EXTERNAL FAÇADE REVIEW, HABITAT

Façade Remedial Consultants Ltd

JULY 23, 2020

Issue – Version 1.0

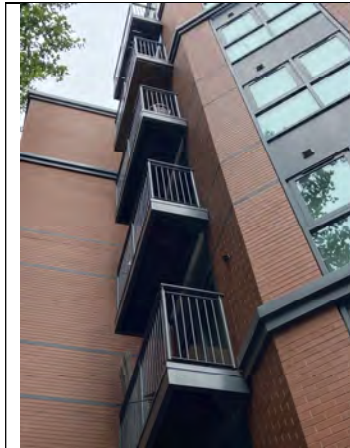
1. In a number of riser cupboards inadequate fire stopping was observed. We recommend a fire compartmentation survey is undertaken to identify all defects, and a remediation programme be implemented.
